CUP06282021-006086/SPR06282021-006089/SUB06282021-006091
Conditional Use Permit/Site Plan/Subdivision
11237 S. Farnsworth Ln

THE ORCHARD

RECOMMENDATION FOR SPECIAL EXCEPTIONS

DATE: September 9, 2021
TO: Craig Evans, Planner
FROM: Ryan C. Kump, P.E., City Engineer 
SUBJECT: **Project Name:** The Orchard at Farnsworth Farms
Plan Case Number: SUB 06282021-006091
Project Address: 11237 S. Farnsworth Ln.

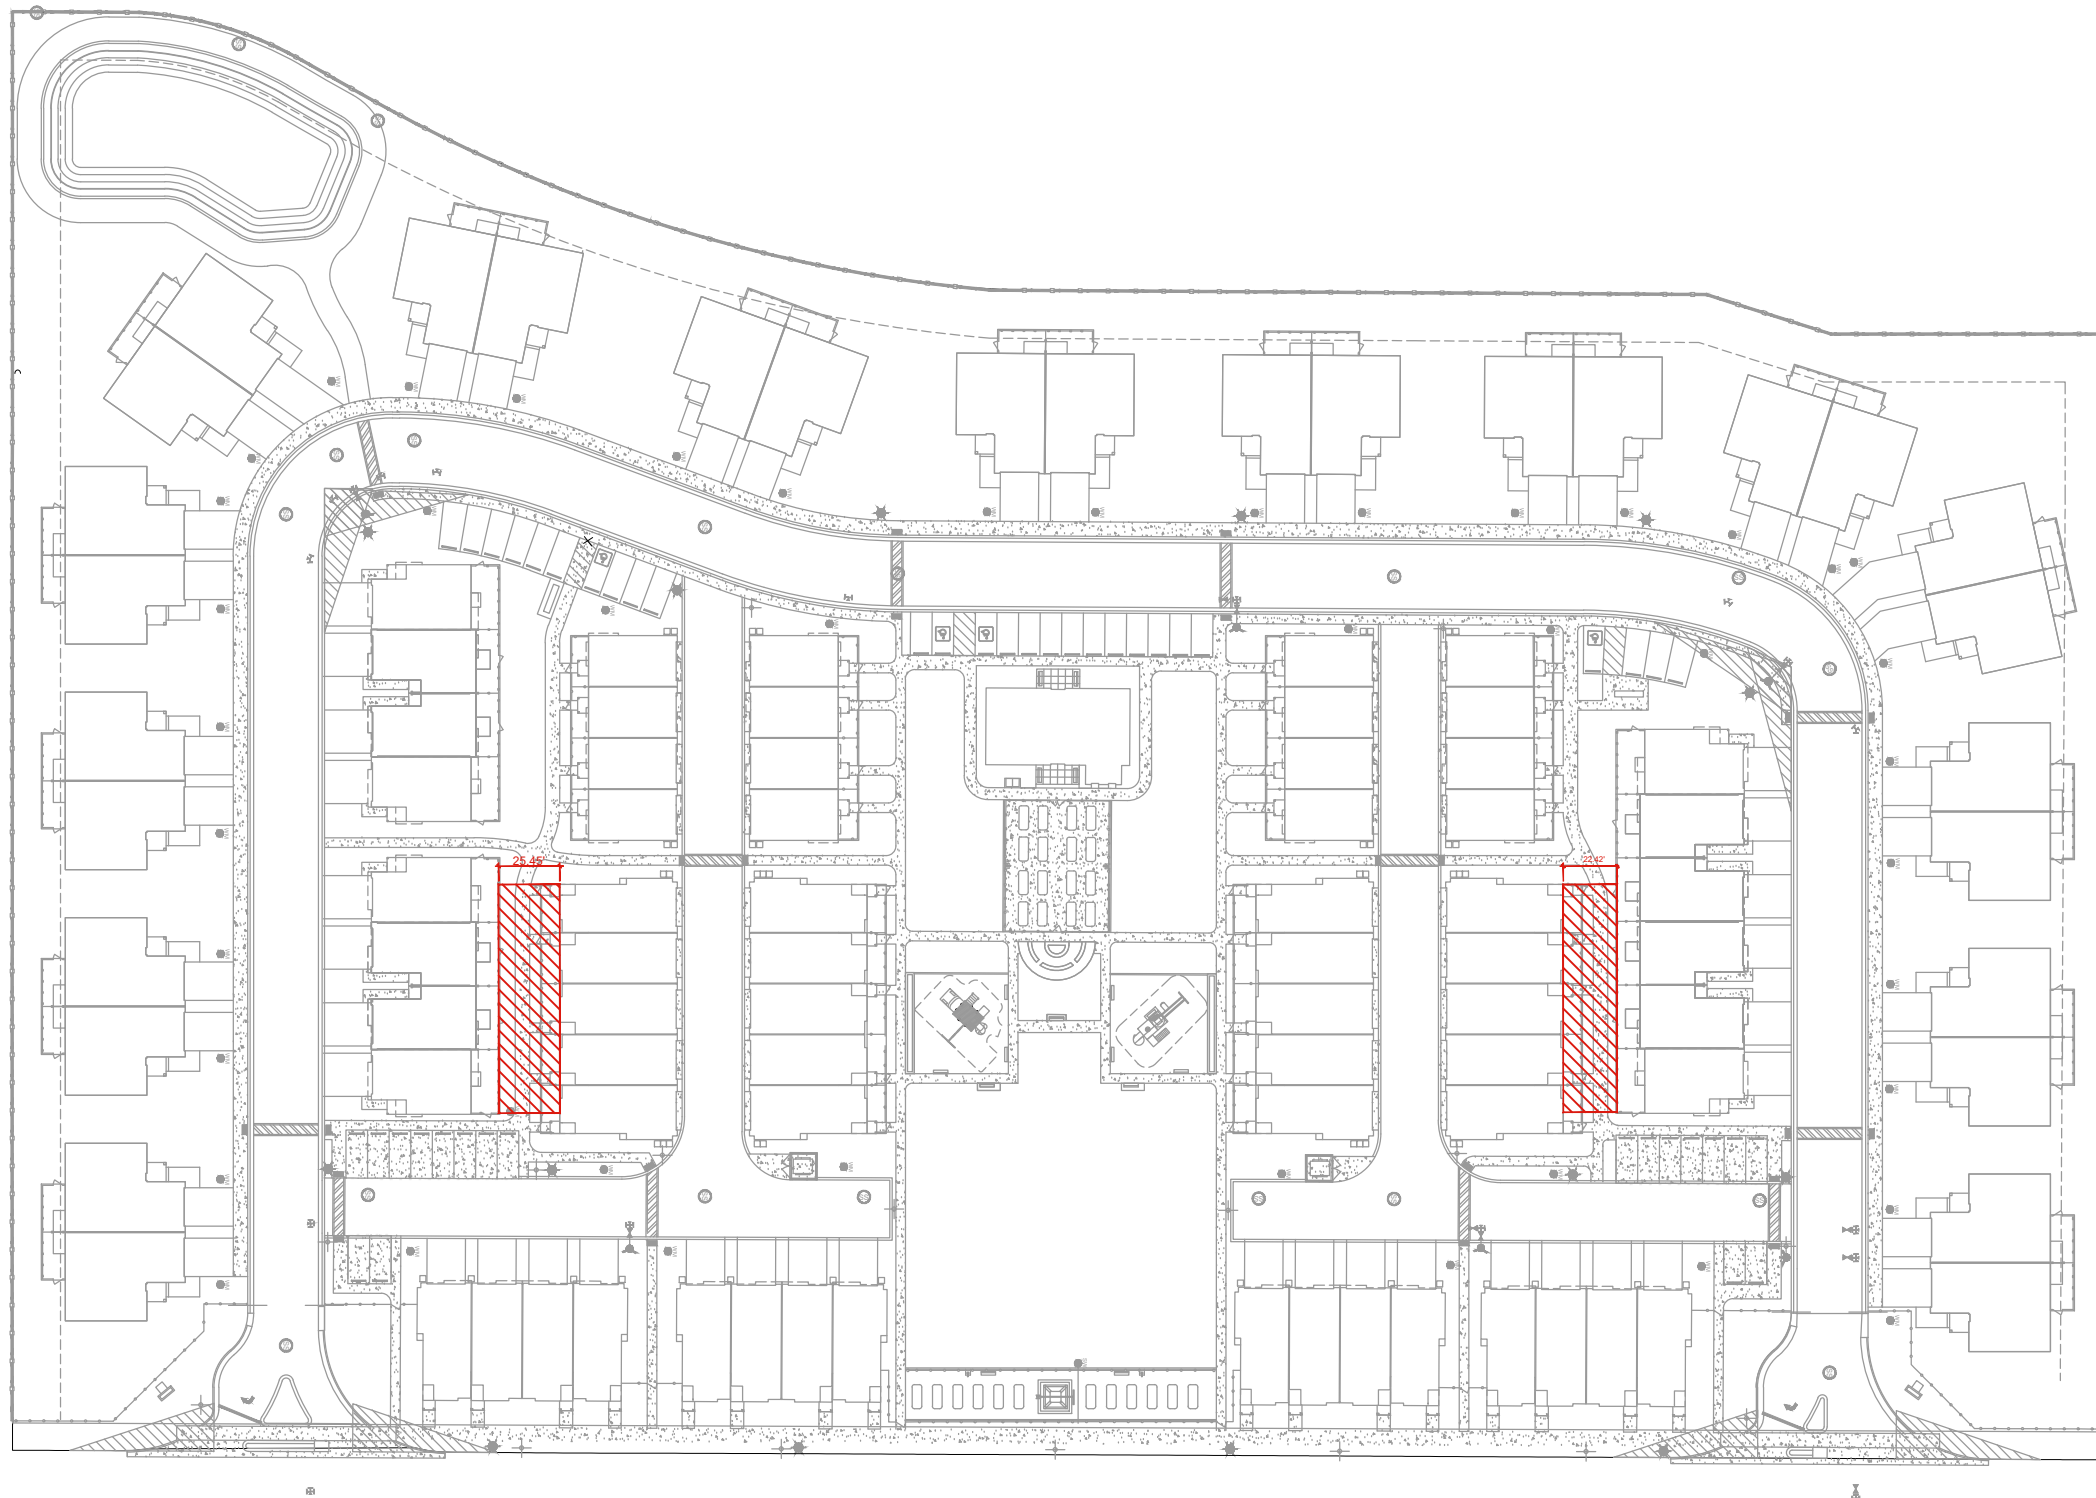
Re: Request to modify width requirement of pedestrian mews for The Orchard at Farnsworth Farms

A portion of the pedestrian mews within the site plan are slightly narrower than the required width of 26 feet. They became narrower than the mew widths shown on the original site plan approved by the City Council after implementing numerous redline modifications received from staff through the redline review process, which shrunk the mews. The mew widths are now 25.45 feet (southern mew) and 22.42 feet (northern mew), which are both just slightly narrower than the 26-foot requirement.

1. Preserve the center open space area to be as consistent as possible from what was originally proposed, and ultimately approved by, the City Council in October 2020. The current site plan has incorporated all city staff redlines and is as consistent as possible with the approved site plan.
2. Shrinking the center open space area to increase the pedestrian mew width would eliminate two rows of orchard trees and shrink the lawn between the playgrounds to an uncomfortable width, thus modifying the center open space area to a level that wouldn't reflect what was originally approved by the City Council. We felt that preserving the center open space was the higher priority.
3. The pedestrian mews are just slightly narrower than the required 26-foot width.

The current site plan design maximizes mew width, while maintaining the look/feel and functionality of the center open space area as approved by the City Council. The attached exhibit reflects the new pedestrian mew widths for your reference.

- Sandy City Council has previously reviewed a concept proposal of this development with these special exceptions and has requested this version of the site plan be taken through development as previously shown.
- Joe Salisbury, DAI, has provided letters outlining the special exceptions in detail, with reasoning and potential benefits for allowing the exceptions. Engineering agrees with the reasoning provided and sees minimal negative impacts to city infrastructure by allowing said special exceptions.
- Public roads, built to full width, are always the preferred development proposal within Sandy City. However, this proposal is adequate as shown and meets minimum engineering requirements.
